Technical Evaluation Report  
of 1985 Meteorological Data  
from the Indian Point Nuclear Power Plant

Submitted by: Gregg L. Andrews  
Battelle Pacific Northwest Laboratory  
P.O. Box 999  
Richland, WA 99352

5/87

FIGURE 4

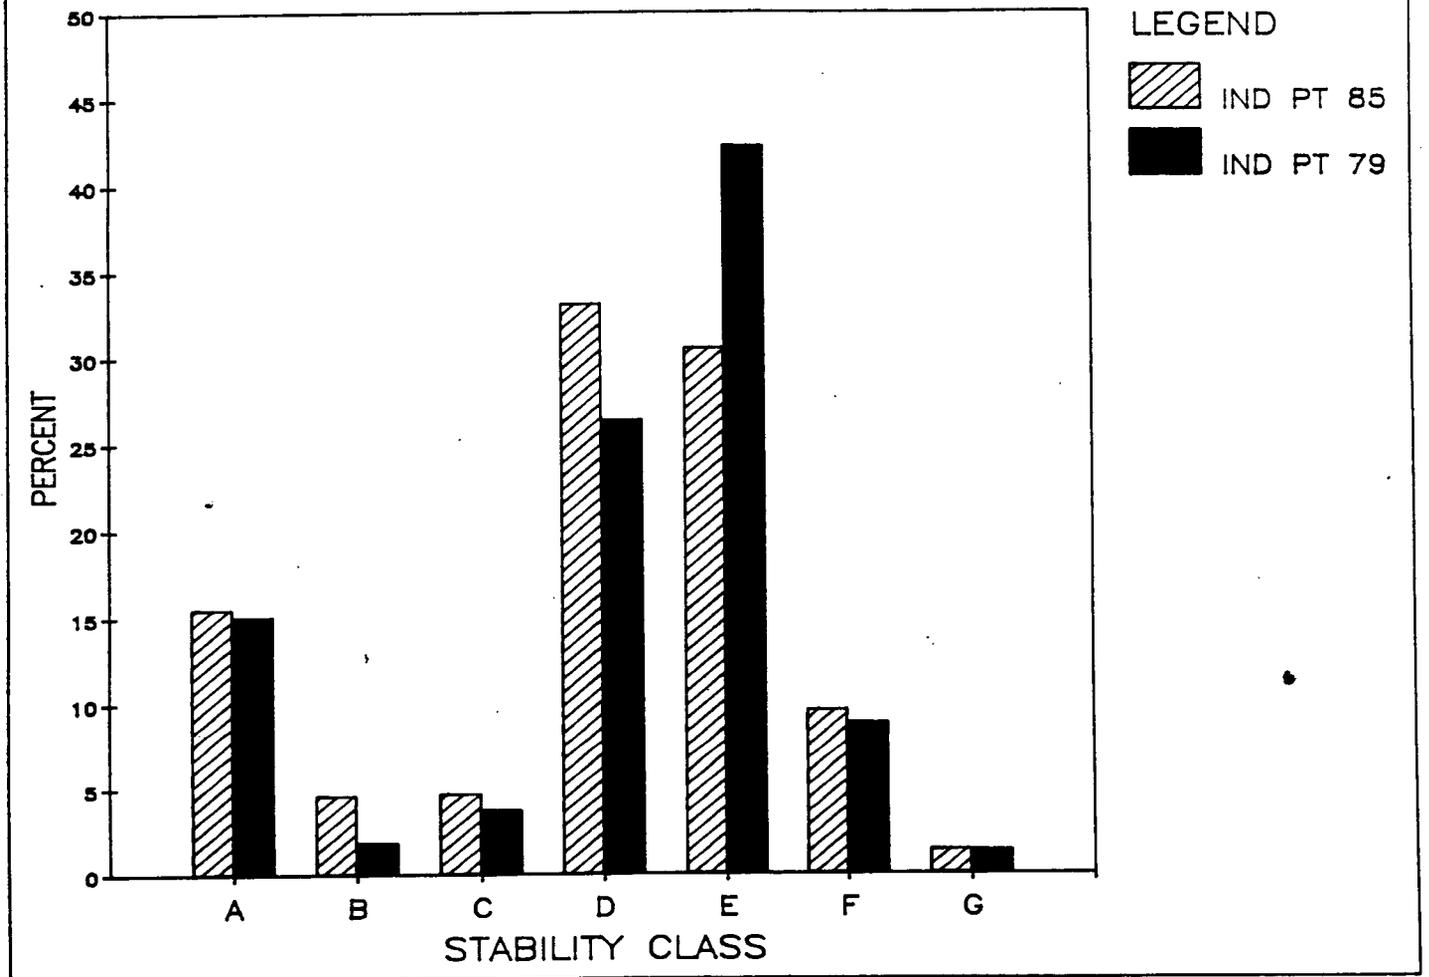
from August 1, 1978 through July 31, 1979 (Fig. 4). The stability classes were determined using the NRC delta-temperature method (Appendix A). The comparison indicates a close relationship between the two data sets. Although there are some discrepancies in the D and E stability classes, it is common to see a shift from one stability class to another on a year-by-year basis.

From examinations of onsite 60.0-10.0 meter delta-temperature distributions it appears that the 1985 60.0-10.0 meter delta-temperature data were climatologically representative, of high quality, and, also, reliable due to their high data recovery (100.0%). It appears that the data would be representative and reliable for use in emergency response actions and routine dose assessments.

FIGURE 5

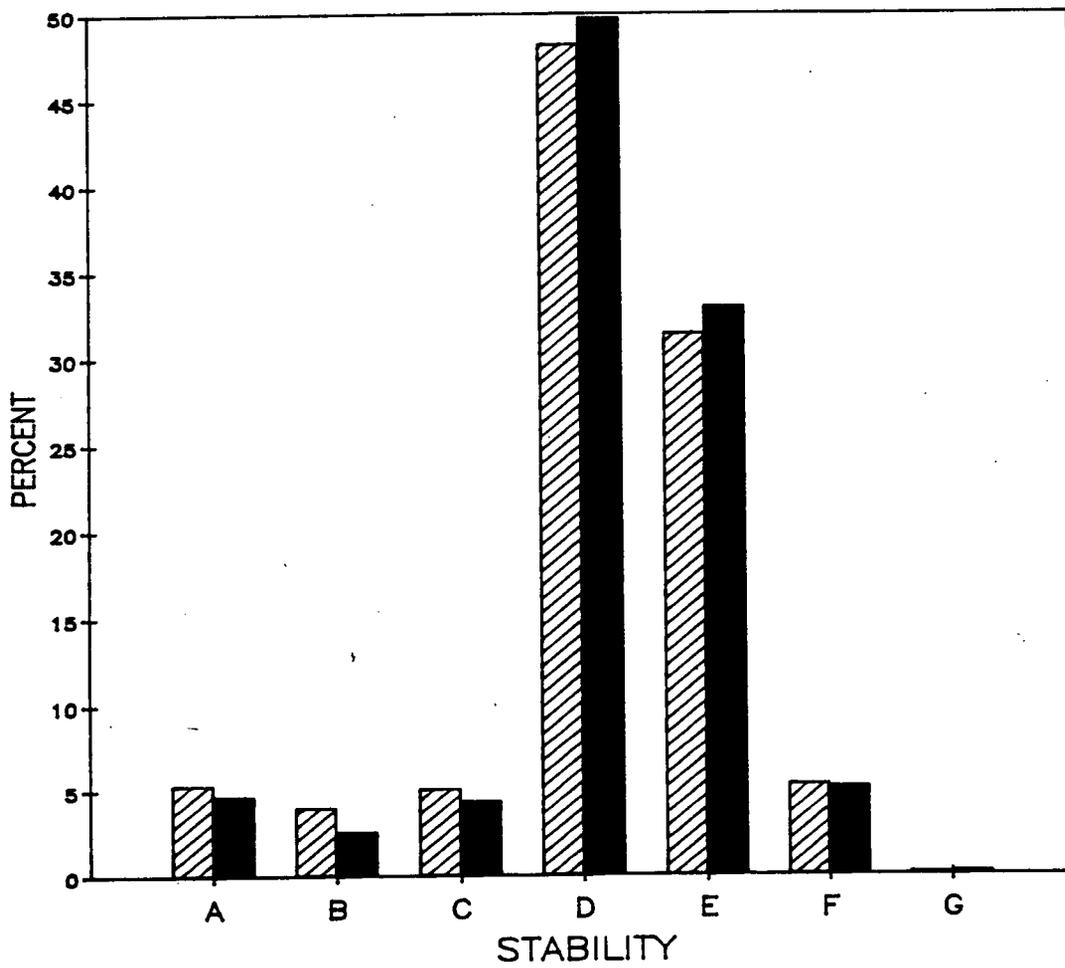
The 1985 Indian Point 122.0-10.0 meter delta-temperature data were compared with previous 122.0-10.0 delta-temperature data (New York Power Authority 1982) from August 1, 1978 through July 31, 1979 (Fig. 5). The stability classes were determined using the NRC delta-temperature method (Appendix A). The comparison indicates a very close relationship between the two data sets.

From examinations of onsite 122.0-10.0 meter delta-temperature distributions it appears that the 1985 122.0-10.0 meter delta-temperature data were climatologically representative, of high quality, and, also, reliable due to their high data recovery (100.0%). It appears that the data would be representative and reliable for use in emergency response actions and routine dose assessments.

FIGURE 6

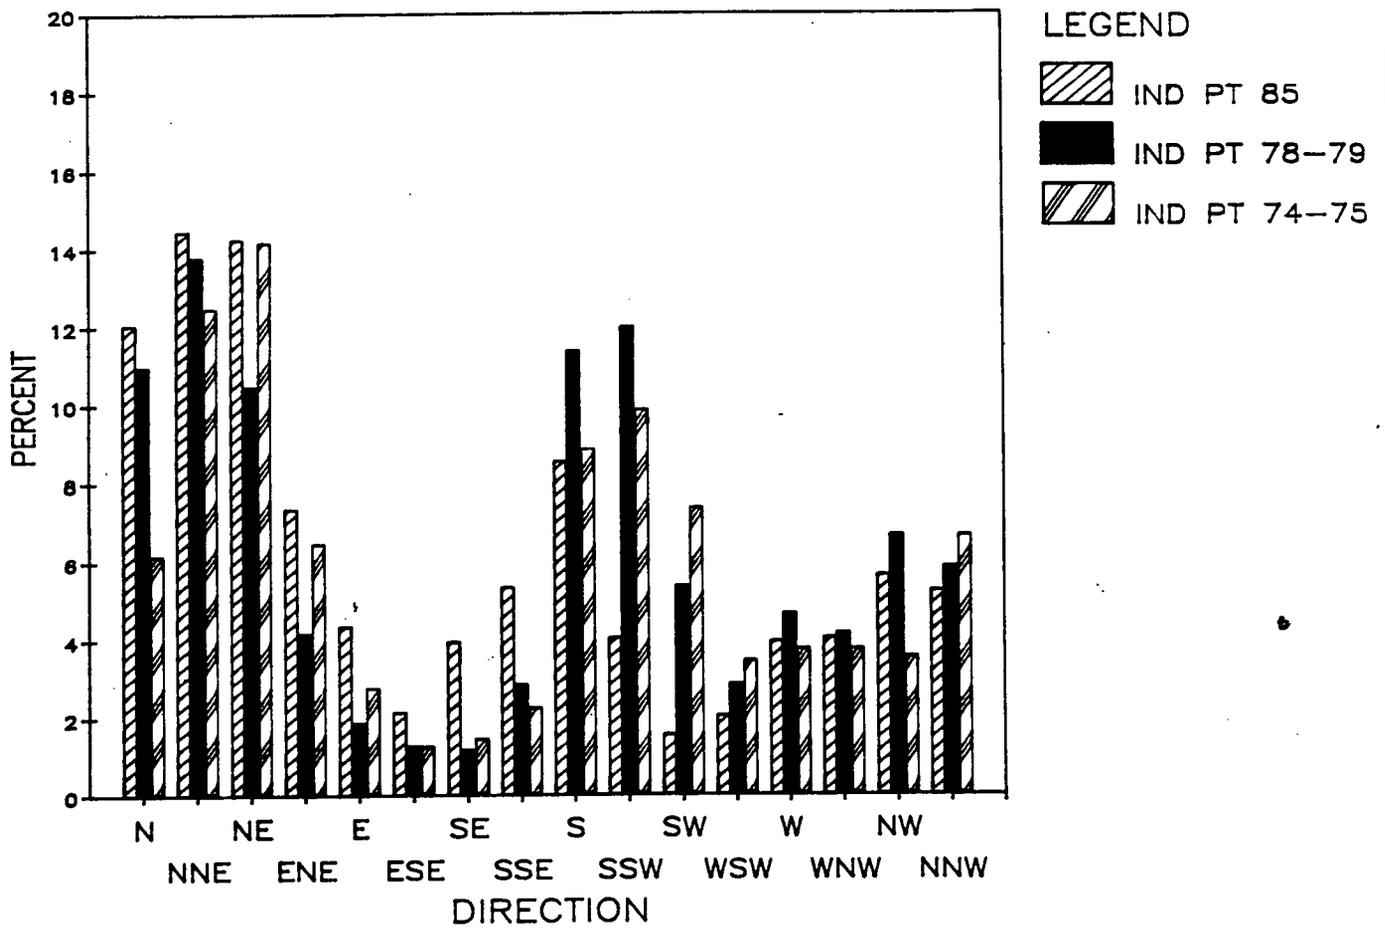
A comparison (Fig. 6) was made between the 1985 Indian Point 10.0 meter wind directions and previous (Aug. 1, 1978 through July 31, 1979 (New York Power Authority 1982) and Jan. 1, 1974 through Dec. 31, 1975 (Verholek 1977)) 10.0 meter wind directions from Indian Point. The comparison shows a reasonably close relationship among the three data sets. The discrepancies that exist between the data sets are more than likely due to the year-by-year change in the weather pattern, and do not necessarily reflect any problems with the data collection system.

FIGURE 7

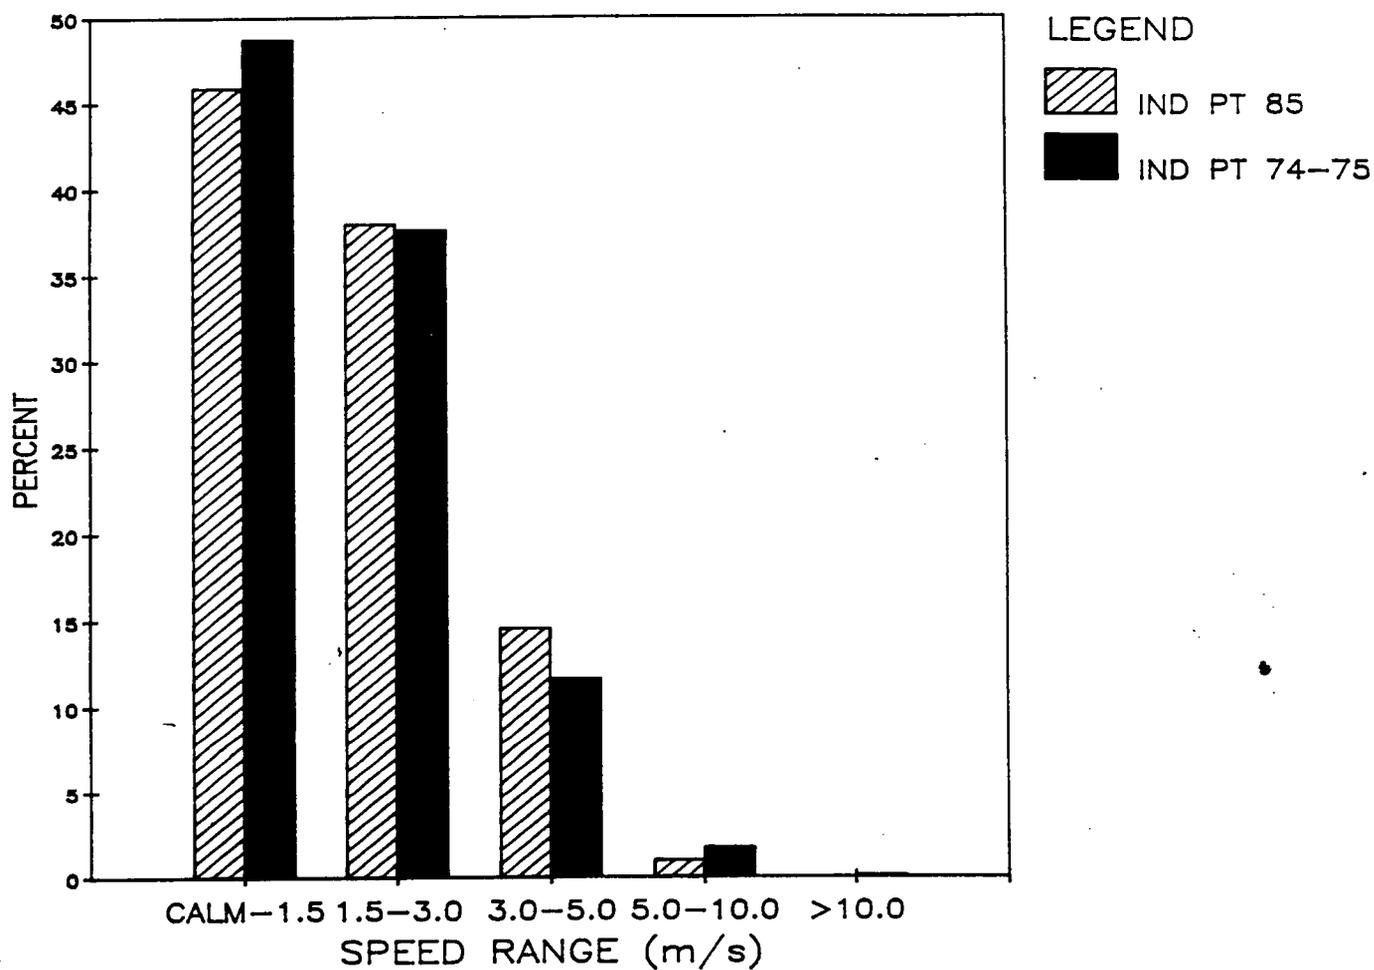
A wind speed comparison between the 1985 Indian Point 10.0 meter data and the January 1, 1974 through December 31, 1975 Indian Point 10.0 meter data are shown in Figure 7. The August 1, 1978 through July 31, 1979 wind speed data were omitted due to the difference in wind speed categories. The comparison shows a very close relationship among the two data sets.

From examinations of the 1985 Indian Point 10.0 meter wind direction and speed frequency distributions it appears that the data were climatologically representative, of high quality and, also, reliable because of their high data recovery (100.0% and 99.9%, respectively). It appears the data would be representative and reliable for use in emergency response actions or routine dose assessments.

FIGURE 8.

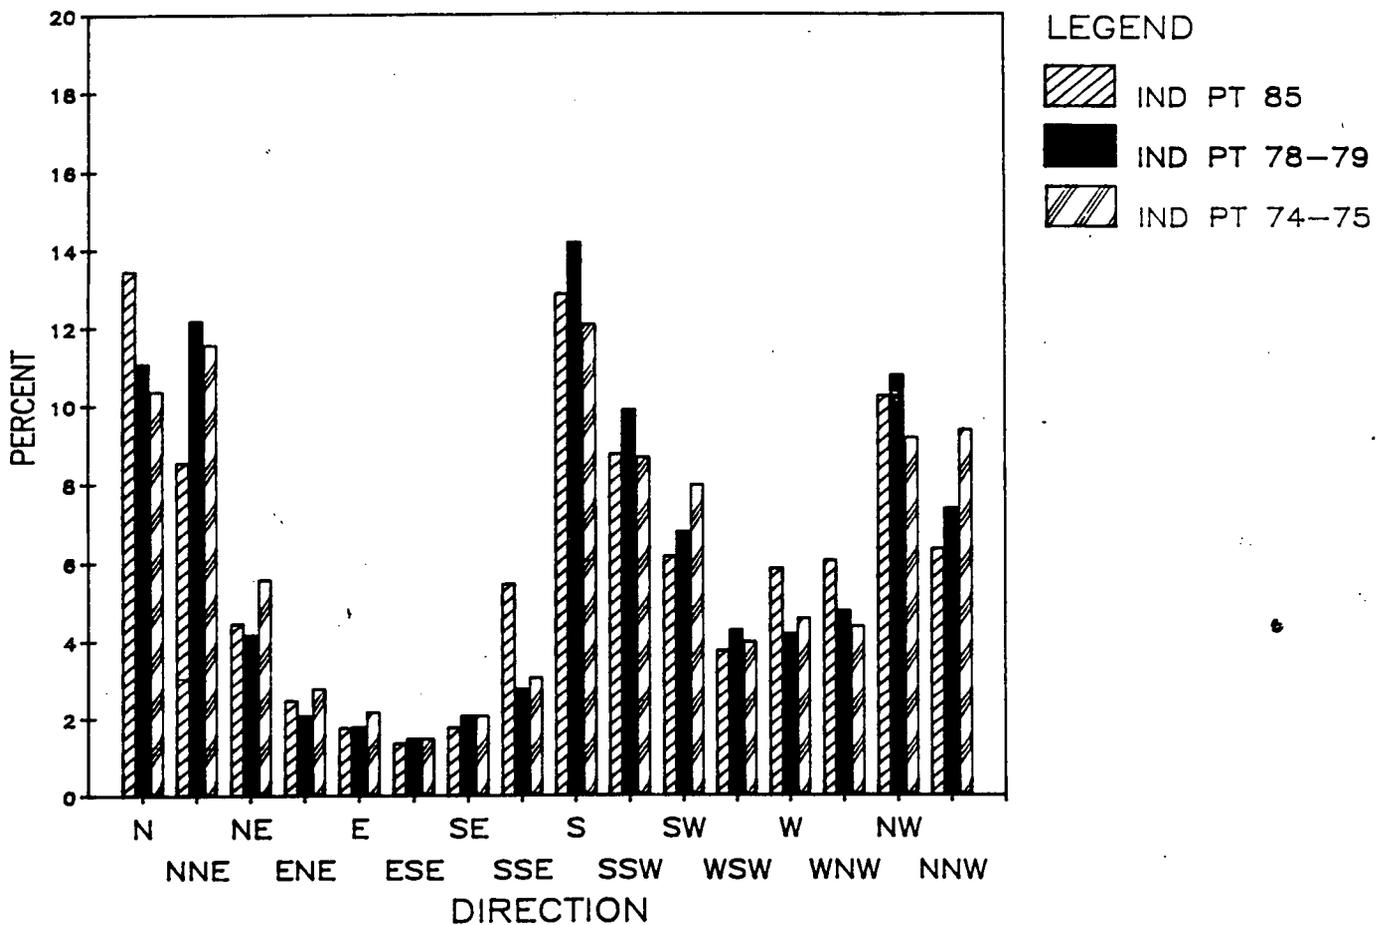
The 1985 Indian Point 122.0 meter wind direction data were compared with previous (Aug. 1, 1978 through July 31, 1979 (New York Power Authority 1982) and Jan. 1, 1974 through Dec. 31, 1975 (Verholek 1977)) Indian Point 122.0 meter wind direction data (Fig. 8). The comparison indicates a close relationship among the data sets. In addition, the 1985 Indian Point 122.0 meter wind speed data were compared with previous (Jan. 1, 1974 through Dec. 31, 1975) Indian Point 122.0 wind speed data (Fig. 9). The August 1, 1978 through July 31, 1979 wind speed data were omitted due to differences in the wind speed categories. Again, the comparison shows a close relationship between the two data sets.

FIGURE 10

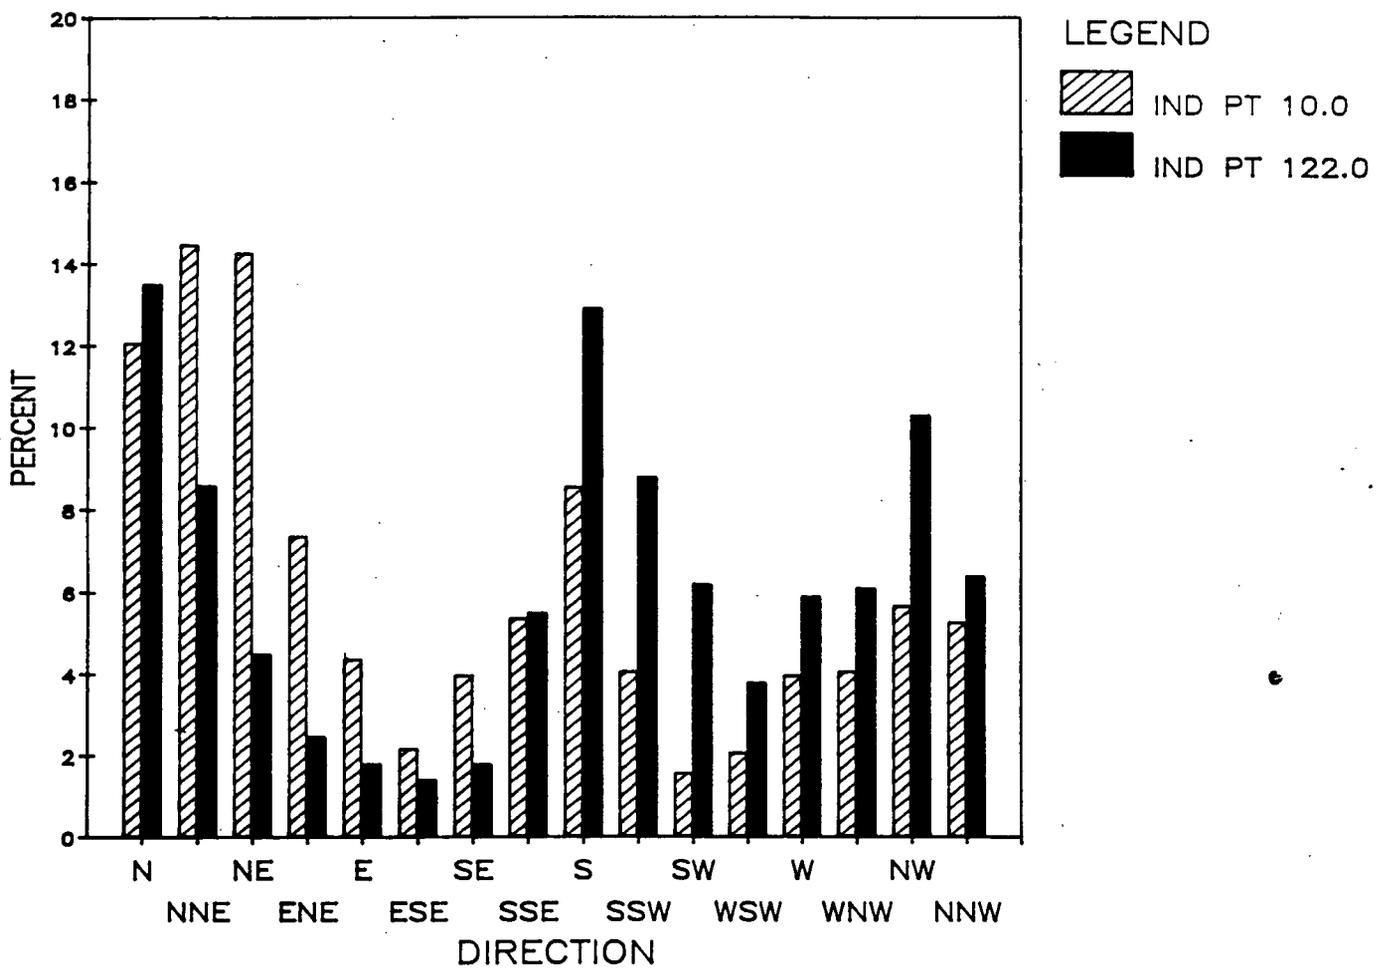
In conjunction with the above comparisons, an intercomparison was made between the wind directions (Fig. 10) and wind speeds (Fig. 11) from the 1985 Indian Point 10.0 meter and 122.0 meter meteorological data. Although the wind direction comparison shows some large differences between the two data sets, they do display the same basic trend; higher frequencies in the north, south, and northwest sectors. Differences between wind direction distributions are common for measurements made at different levels (e.g., 10.0 meter vs 122.0 meter); especially when the interval between the two levels is large. The lower-level winds tend to turn counter-clockwise during low pressure events and clockwise during high pressure events relative to the upper-level wind direction. Other factors such as terrain, obstructions and vegetation, and/or local mesoscale circulations may also generate different frequency distributions for two different levels of wind direction. The wind speed comparison shows the expected distribution between lower- and upper-level wind speeds; the lower-level winds are skewed more toward the slower wind speeds while the upper-level winds are skewed toward the higher wind speeds.
